November 1, 2007
E-25747

Subject: Application for Amendment 1 of the NUHOMS® HD Certificate of Compliance
No. 1030 for Spent Fuel Storage Casks, Revision 0

Figure 4-37
Time-Temperature History for TC Backfill Operations

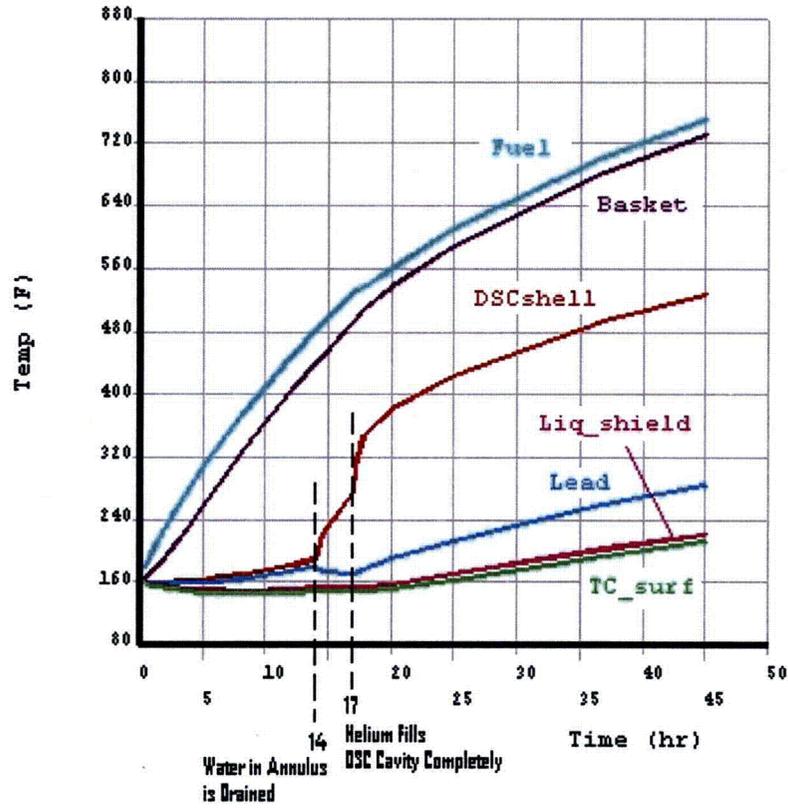
Section #	Page #	Reason for Change
Figure 4-34	1 page	Clarify figure title, Temperatures for TC backfill operations
Figure 4-35	1 page	Figure Deleted
Figure 4-36	1 page	Figure Deleted
Figure 4-37	1 page	Clarify figure title, Time-Temp. History for TC backfill operations
		Appendix 4.16.3
	1 page	New Appendix to discuss the addition of CE 16x16 Fuel
		Appendix 4.16.4
	1 page	New Appendix to discuss reduction in ambient temperature to -21 °F
		Chapter 5

The time limit to start backfilling of the transfer cask with helium must be within 28 hours after drainage of the annulus water based on the time-temperature history curve shown in Figure 4-37.

Figure 4.16.3-1

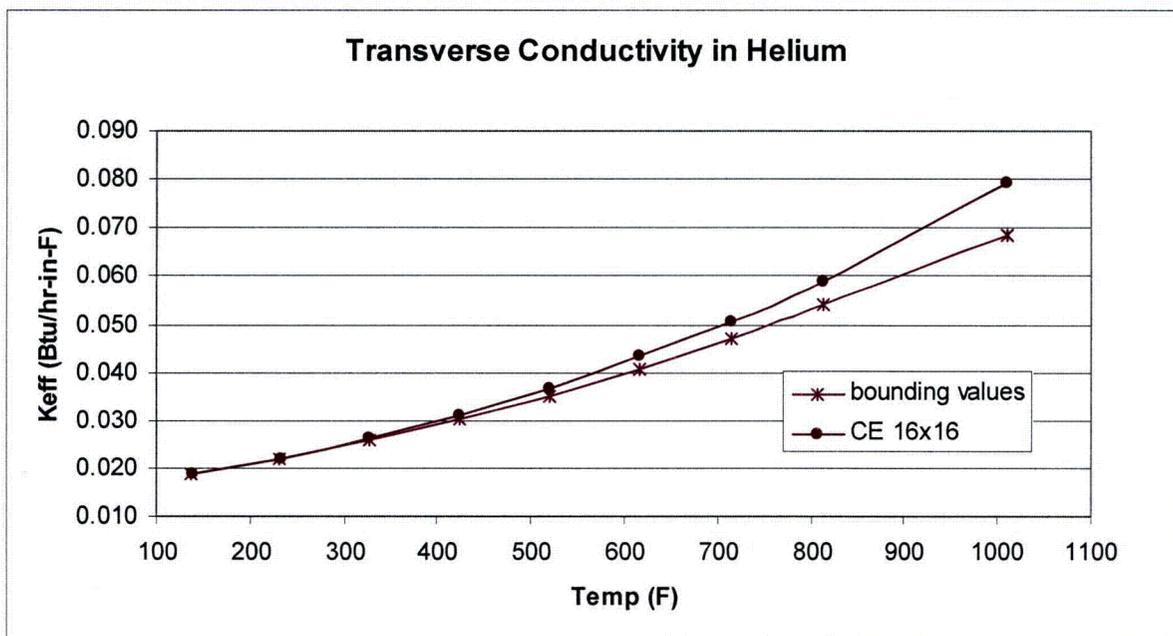
The effective transverse conductivity of fuel assemblies are plotted in Figure 4.16.3-1, which includes CE 16x16 fuel. The bounding values shown herein correspond to those from Chapter 4, Figure 4-41.

Figure 6-20
CE 16x16 Class Assembly – Optimum Pitch KENO Model with BPRAs

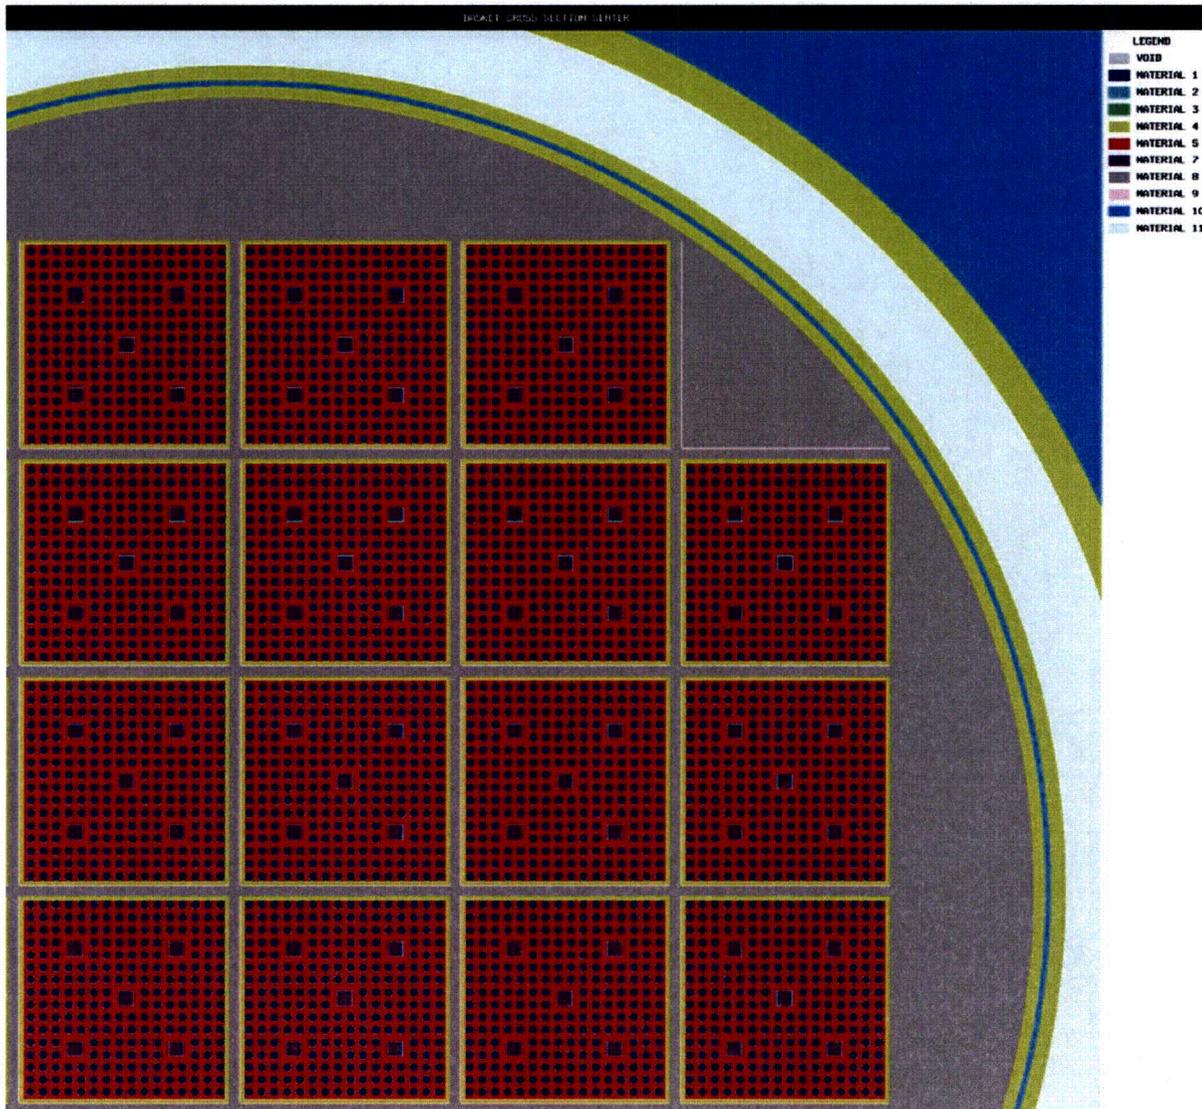
Table 6-36	4 pages	New Table for CE 16x16 results
Table 6-37	3 pages	Data from Old Table 6-34
Table 6-38	4 pages	New Table for CE 14x14 results
Table 6-39	4 pages	New Table for CE 16x16 results
Table 6-40	4 pages	New Table for CE 16x16 results
Figure 6-14	1 page	Modified to show CE 14x14 model
Figure 6-20	1 page	New Figure for CE 16x16 models with BPRA
Chapter 8
